From: millenjohn@me.com <millenjohn@me.com>
Sent: Thursday, January 19, 2023 12:32 AM
To: Maryanne Cronin <Maryanne.Cronin@longbeach.gov>; CityClerk <CityClerk@longbeach.gov>
Cc: 'David & Kathy Walker' <walkerdk85@gmail.com>; bafranssen@gmail.com; liquidmen@aol.com
Subject: Question for Jan 24, 2023 5pm 4101 Long Beach Blvd (fire station 9)

On agenda:	1/24/2023	Final action:
Title:	Declare ordinance amending Ordinance No. C-1015 to repeal and remove the five-foot-special setback along the west side of Long Beach Boulevard where it fronts the Fire Station No. 9 project at 4101 Long Beach Boulevard read for the first time and laid over to the next regular meeting of the City Council for final reading; Approve Site Plan Review (SPR21-050) for clearance of an existing 0.4-acre site and construction of a new two-story (12,780 square foot) Fire Station No. 9 with three (3) drive-through apparatus bays located at 4101 Long Beach Boulevard; Approve Standards Variances requests to allow: 1) a driveway on Randolph Place located less than thirty feet (30') from an intersection (SV22-006) and 2) a curb cut greater than the 24-foot maximum on Randolph Place (SV22-007); and Approve a Lot Merger

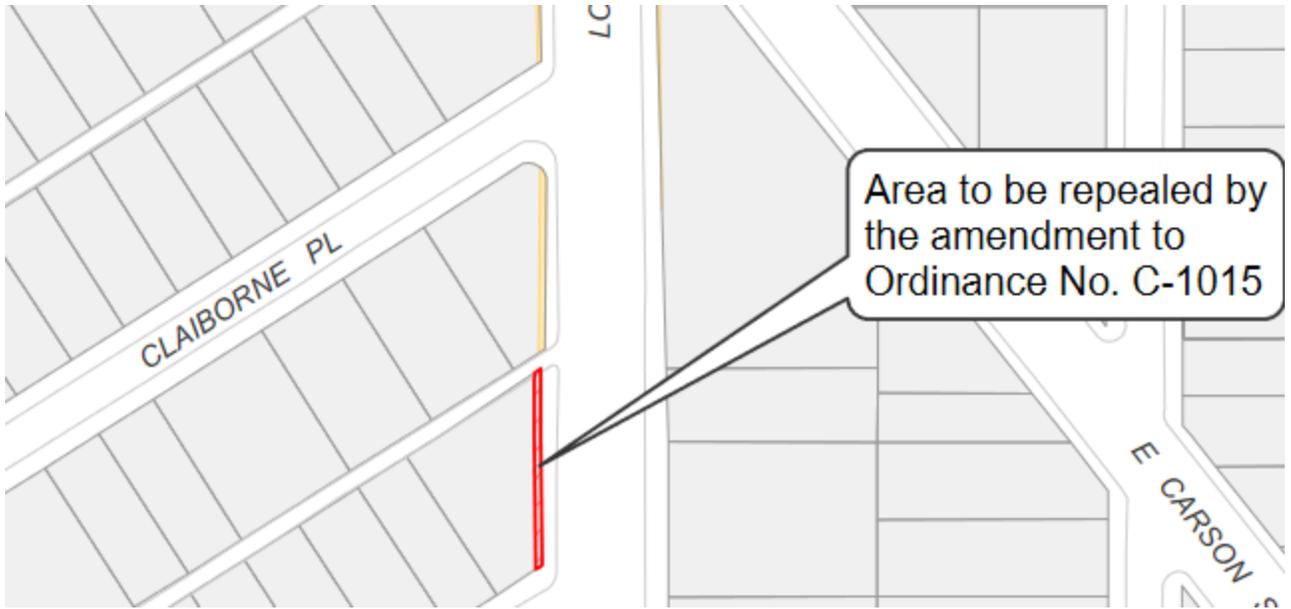
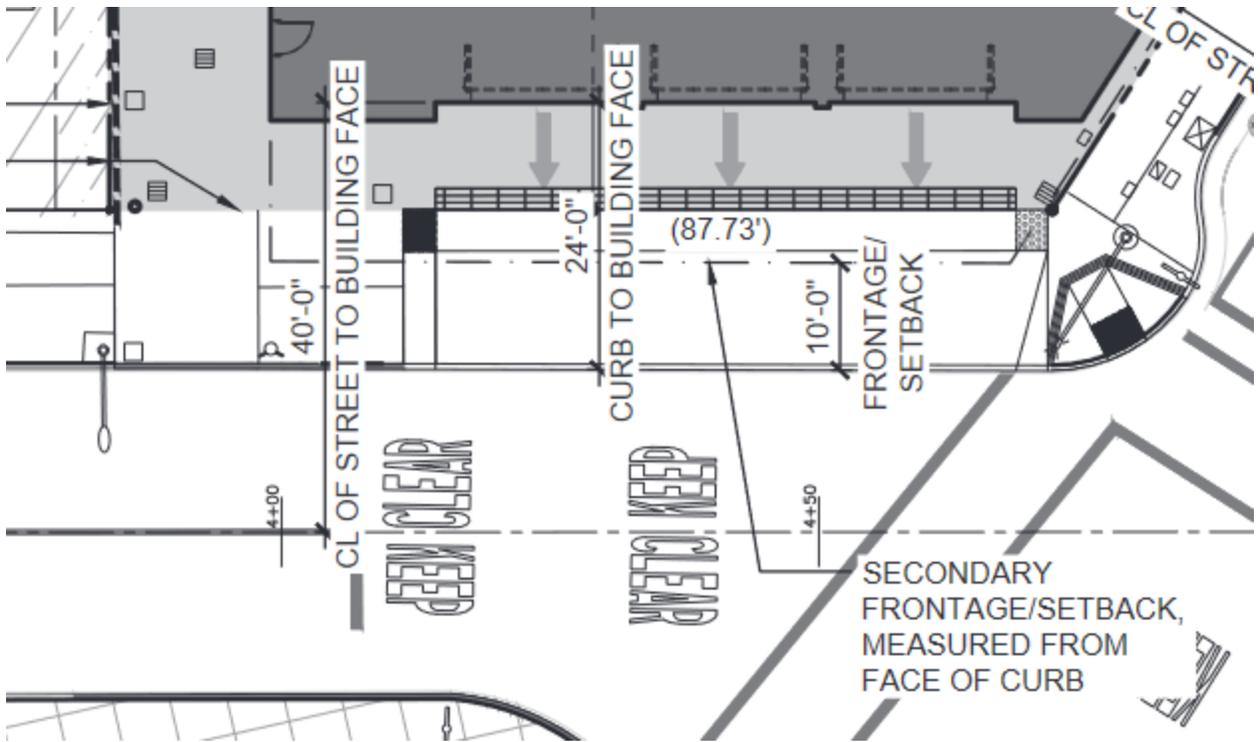
Even with all the merging of lots it requires numerous ordinance and variance changes, and it requires the alley to be the fire station main entrance/driveway, why is this site acceptable?

Comment: After merging 3 lots it is only 0.38 acre and not close the 1 acre lot the city originally pursued. This site requires an unconventional use of the alley as the main driveway entrance to the fire stations. **Where else is this done?**

How will the existing structure provide privacy nearby properties? Will they have no windows on the second floor or permanent low visibility screens? The proposed fire station is two stories and presently only single story building exist. All five nearby properties (North and West) will no longer have a private back yard and will have potential view inside their homes 24hrs day

With the alley being the main fire station entrance from long beach Blvd., will the residence be able to exit the alley onto long beach Blvd.?

How is the city addressing the reduction/elimination of 13 parking spots from Randolph place (~5 spots) and long beach Blvd (~8 spots)? Similar to what was done when new fire station 12 was built, I expect the new fire station will require red curbs on Long Beach Blvd. and Randolph.
